Access Compliance Report Public Rights-of-Way (Curb Ramps)

Main Street: BLACK_CHERRY_ST		Cross Street: TERRASTAR_LN		Location:	NE
ADA ID: RPAT211101093638	Ramp Type: Type 4 - Parallel	Initial Pass/Fail: Pass	Overall Compliance: No	Severity Score:	12
Codes/Mitigation Info/Possible Solution			Field Measurements/Component Compliance

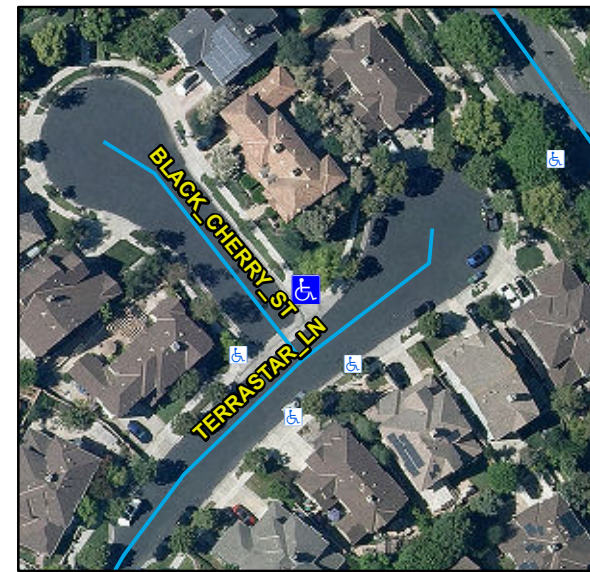
Compliance	Description	Data	Compliance	Description	Data
N/A	Ramp Length LT (in)	85	N/A	Ramp Length RT (in)	78
Yes	Ramp Width LT (in)	52	Yes	Ramp Width RT (in)	54
Yes	Ramp Run Slope LT (%)	5	Yes	Ramp Run Slope RT (%)	7.7
No	Ramp Cross Slope LT (%)	4.2	Yes	Ramp Cross Slope RT (%)	1
N/A	Landing Present	Yes	No	DWS Provided	No
N/A	Landing Length (in)	52	N/A	DWS Contrast	N/A
Yes	Landing Width (in)	50	N/A	DWS Length (in)	N/A
No	Landing Run Slope (%)	3.8	N/A	DWS Full Width	N/A
No	Landing Cross Slope (%)	2.6		DWS Offset Type	N/A
N/A	Landing Movement Obstructed?	No	N/A	DWS Offset Left (in)	N/A
	Landing Movement Type	Curb	N/A	DWS Offset Right (in)	N/A
N/A	Landing Shared	No			
N/A	Clear Space	Yes			
N/A	Clear Space To Crosswalk (in)	48			
N/A	Marked Crosswalk 1	No	N/A	Marked Crosswalk 2	No
	Crossing 1 Direction	W		Crossing 2 Direction	S
	Marked Crosswalk 1 Width (in)	N/A		Marked Crosswalk 2 Width (in)	N/A
N/A	Ramp Inside Crosswalk 1	N/A	N/A	Ramp Inside Crosswalk 2	N/A

Crossing 1 Slope (%)	1		Crossing 2 Slope (%)	1.9
	Crossing 1 Cross Slope (%)	1.6		Crossing 2 Cross Slope (%)	1.9
Yes	Gutter Ponding	No	Yes	Curb Slope	5.8
Yes	Gutter Lip Height (in)	0		Road Run Slope (%)	0.7
Yes	Gutter Run Slope (%)	1.5		Road Cross Slope (%)	3.8
No	Gutter Cross Slope (%)	3	No	Perpendicular Joint Present	No
Yes	Overall Surface Condition	Acceptable			
	Cross Gutter Present?	Yes		Spandrel Present?	Yes
	Replace Cross Gutter?	No		Replace Spandrel?	No

Remove & Replace Curb Ramp With Two New Directional Ramps or Equivalent. Remove & Replace Gutter.
